ADDENDUM 1 18-0009 EMS POST 8 REMODEL AND BUILDING REPAIRS

Addendum Number One

To The Drawings and Specifications for Sedgwick County **EMS Post 8**

Mechanical Addenda #1

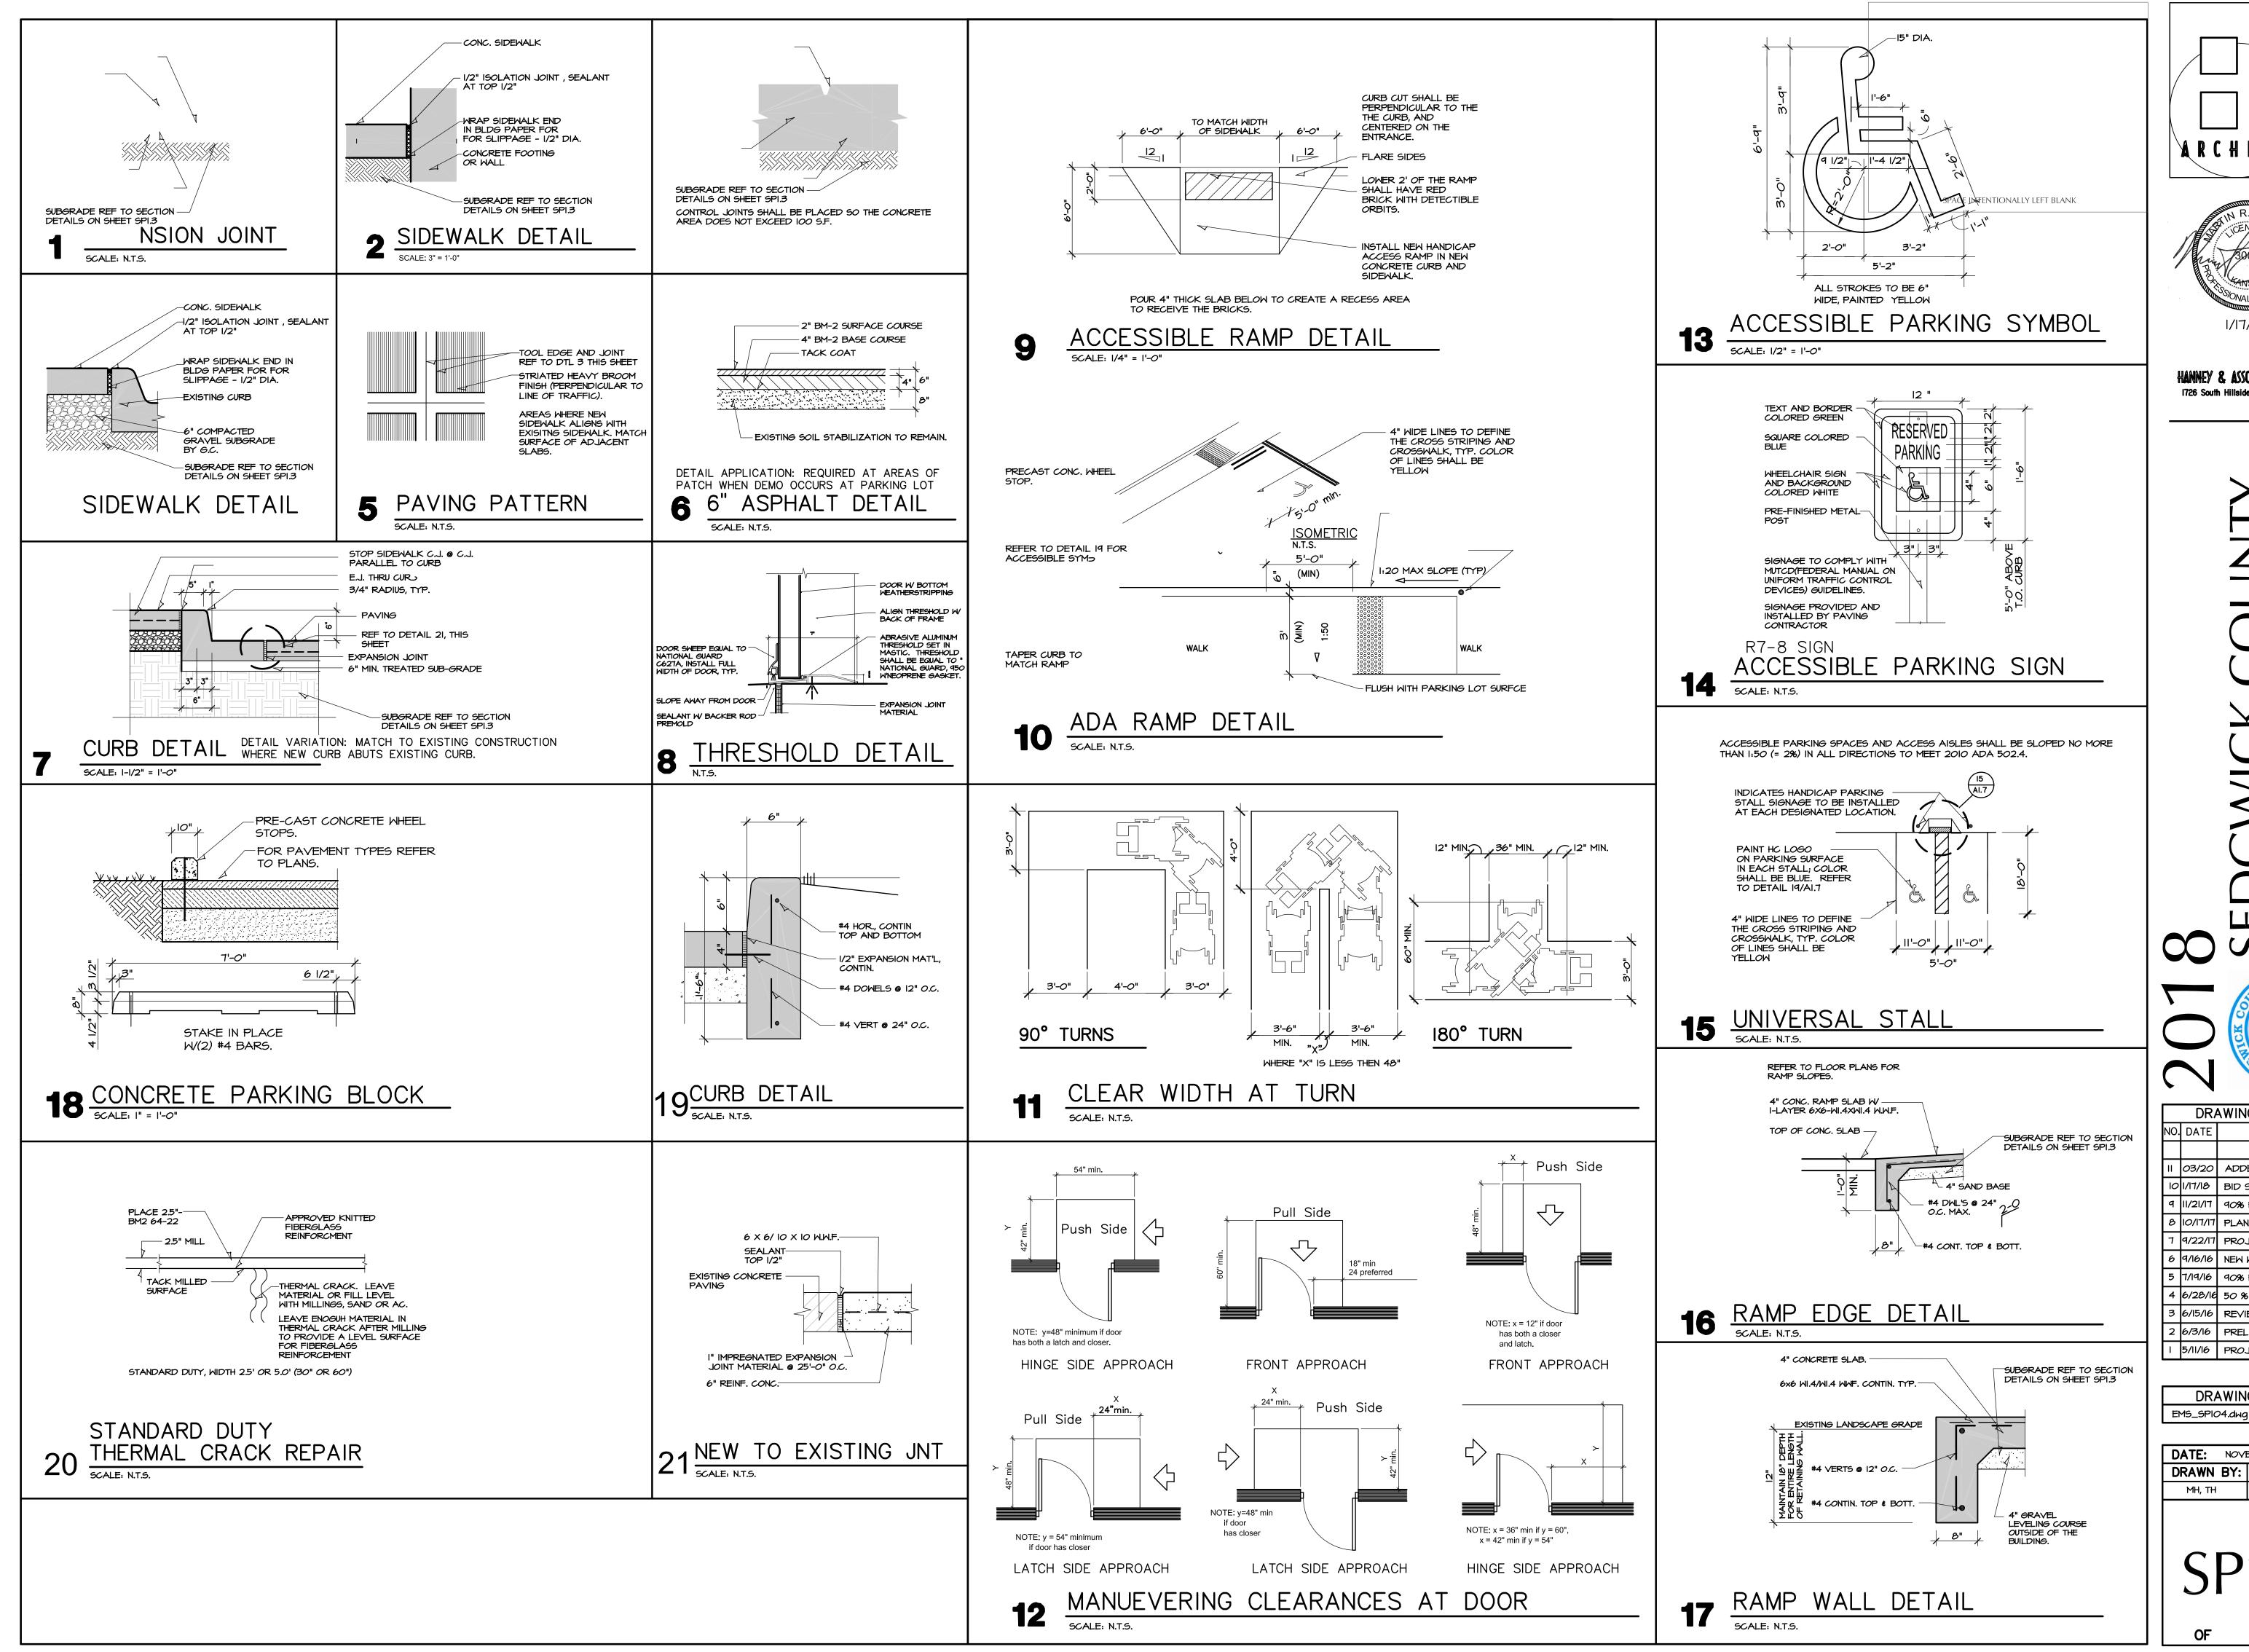
| EXHAUST FAN SCHEDULE | | | | | | | | | | | | | |
| E.F. 1 | соок | 150 ACRUB | 525 | .6 | .13 | 1/4 | 5.5 | 4114 | BELT | 1048 | 115/1/60 | 90 | 2,3,8 |

A NORTH AREA - PARTIAL PLAN

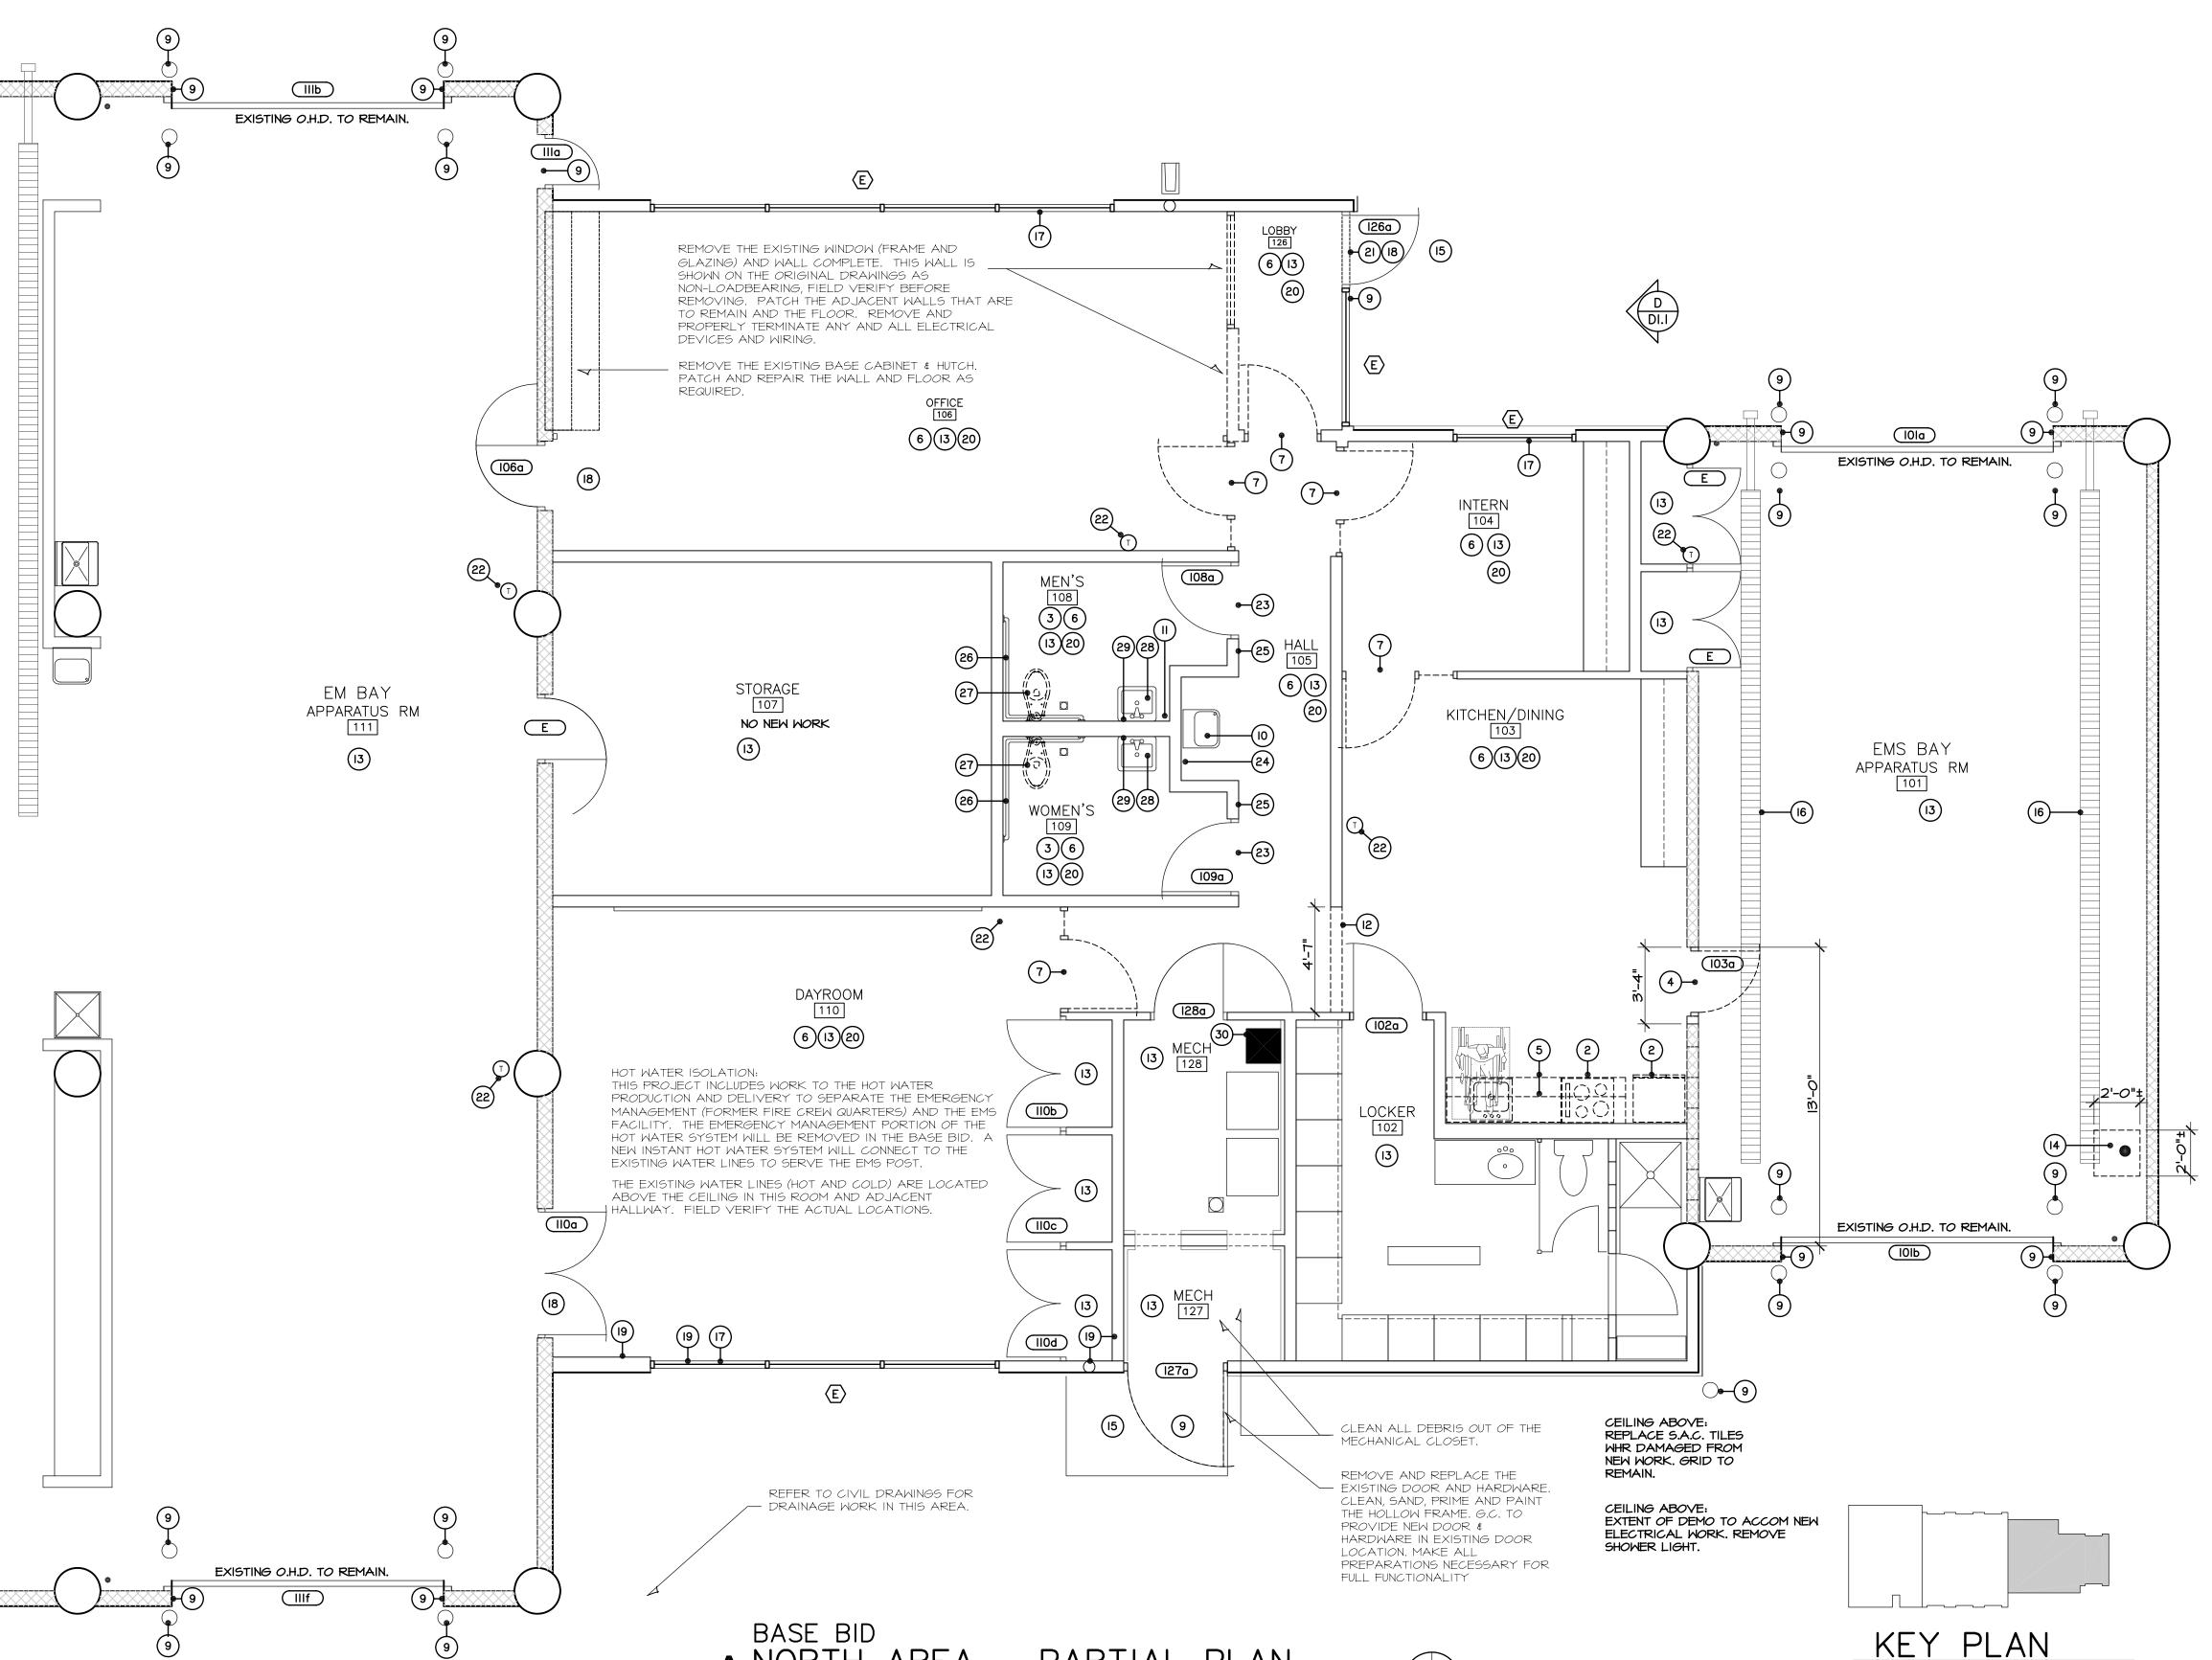
2.5 Sheet D1.0

Photo indicators used in design were left "turned on". These directional detail arrows shall be deleted from this sheet. A revised sheet D1.0 is included in this addendum.
